ADDENDUM No. 5

Airfield Lighting Vault Expansion AIP # 3-33-0011-TBD-2025 Bid # FY25-804-38

at the Manchester - Boston Regional Airport

Date:	April 18, 2025
	of firms submitting proposals for the work named above is called to the following modifications to the swere issued.
a part of the	forth herein, whether of clarification, omission, addition and/or substitution, shall be included and form Proposer's submitted materials and the corresponding contract when issued. No claim for additional, due to lack of knowledge of the contents of this Addendum will be considered.
provided on t	's are advised that receipt of this notice and all attached material must be duly acknowledged in the space the signature page of the proposal documents, and by the insertion of this sheet, signed, and submitted roposal package.
	This form must be signed and attached to the original copy of your submission.
	The attached sheets contain information or clarifications requested or discussed.
Receipt of	of Addendum No. 5 to the REQUEST FOR PROPOSALS for Airfield Lighting Vault Expansion at the MANCHESTER-BOSTON REGIONAL AIRPORT is hereby acknowledged.

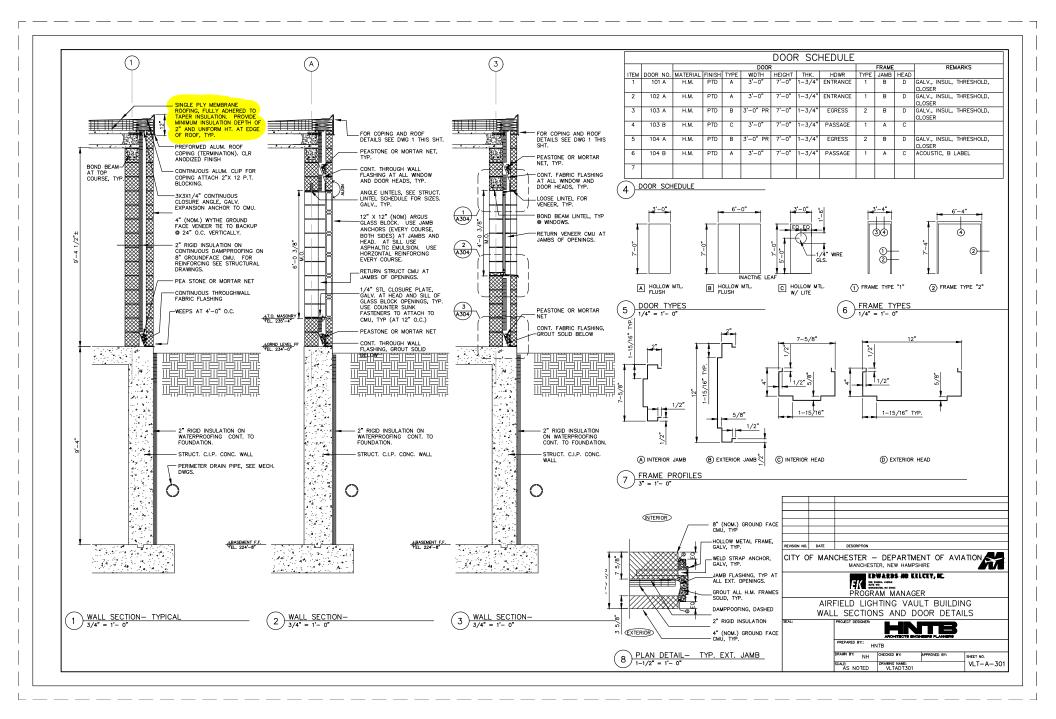
Q5: The demolition drawing, AD-101 is calling for the existing roof membrane to be removed and the existing insulation and AVB is to remain. The new roof plan, on drawing A-102, is calling for new rigid insulation to be added on top of the existing insulation to achieve a minimum R-30 at any point, however no information has been provided on the existing roof makeup. Please provide the makeup of the existing roof so we can determine how much insulation needs to be added to achieve R-30.

A5: For existing roof insulation, see Detail 1 / VLT-A-301 (attached) from the record drawing set when the vault was originally constructed. Minimum insulation depth is 2".
